Los Esteros Critical Energy Facility
1515 Alviso Milpitas Road
San Jose, CA 95134

RE: Temporary Transmission Line Amendment

Please find enclosed for filing, Amendment 2 for the Los Esteros Critical Energy Facility.

Los Esteros Critical Energy Facility Amendment Application #2

FIGURE 1

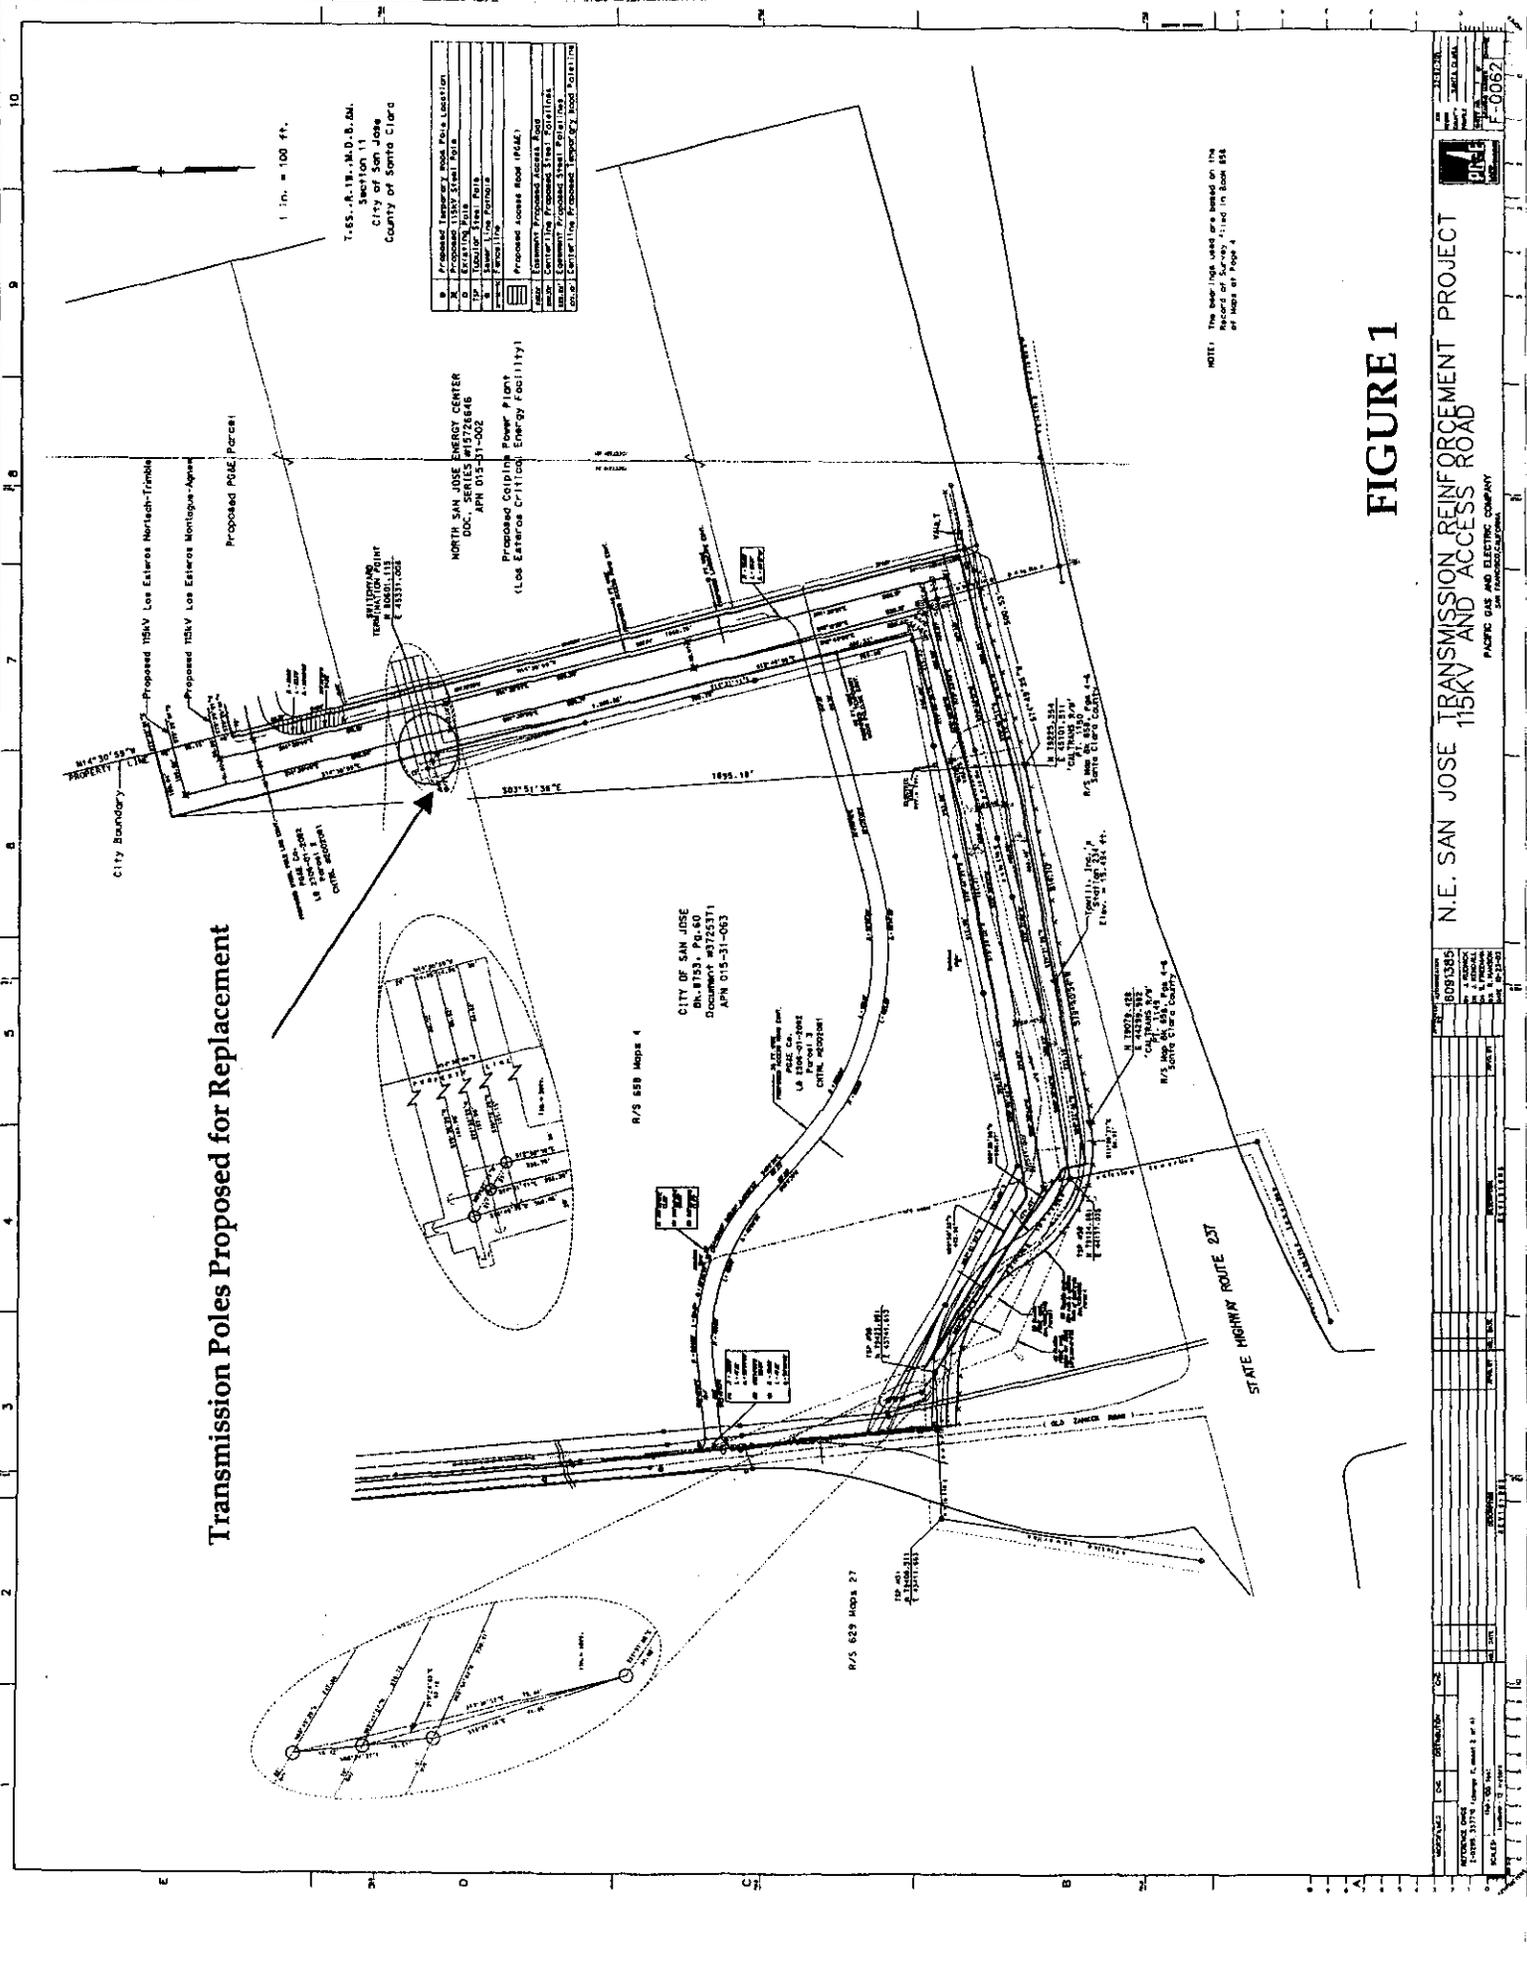
Currently, the LECEF is utilizing a temporary interconnect to PG&E's system with a .6 mile temporary tap line to the Nortech-Trimble 115 kV line. Effective 5/24/2003 this temporary connection can no longer be maintained by PG&E and the LECEF will have to be connected via a shorter temporary tap line (one span out from the LECEF substation) to PG&E's new Los Esteros-Nortech 115 kV line. This new temporary interconnection is expected to be completed by PG&E on 5/26-27/2003. The proposed changes to the project's temporary interconnection involves shortening the existing temporary interconnect, from 0.6 miles to 250 feet, and replacement of three 60 foot wooden poles with three taller wooden poles (65 feet) to facilitate an aerial connection directly to PG&E's new Los Esteros-Nortech circuit. The remainder of the temporary tap line poles will be removed as licensed. The new temporary tap line will be owned and operated by PG&E. Only minor relay setting changes are required at the LECEF facility for protection, and PG&E has installed a direct underground fiber optic line between LECEF and Los Esteros Substation for communication purposes between the two facilities. Figure 1 shows poles to be removed and those to be replaced.

Currently, the LECEF is utilizing a temporary interconnect to PG&E's system with a .6 mile temporary tap line to the Nortech-Trimble 115 kV line. Effective 5/24/2003 this temporary connection can no longer be maintained by PG&E and the LECEF will have to be connected via a shorter temporary tap line (one span out from the LECEF substation) to PG&E's new Los Esteros-Nortech 115 kV line. This new temporary interconnection is expected to be completed by PG&E on 5/26-27/2003. The proposed changes to the project's temporary interconnection involves shortening the existing temporary interconnect, from .6 miles to 250 feet, and replacement of three 60 foot wooden poles with three taller wooden poles (65 feet) to facilitate an aerial connection directly to PG&E's new Los Esteros-Nortech circuit. The remainder of the temporary tap line poles will be removed as licensed. The new temporary tap line will be owned and operated by PG&E. Only minor relay setting changes are required at the LECEF facility for protection, and PG&E has installed a direct underground fiber optic line between LECEF and Los Esteros Substation for communication purposes between the two facilities. Figure 1 shows poles to be removed and those to be replaced.
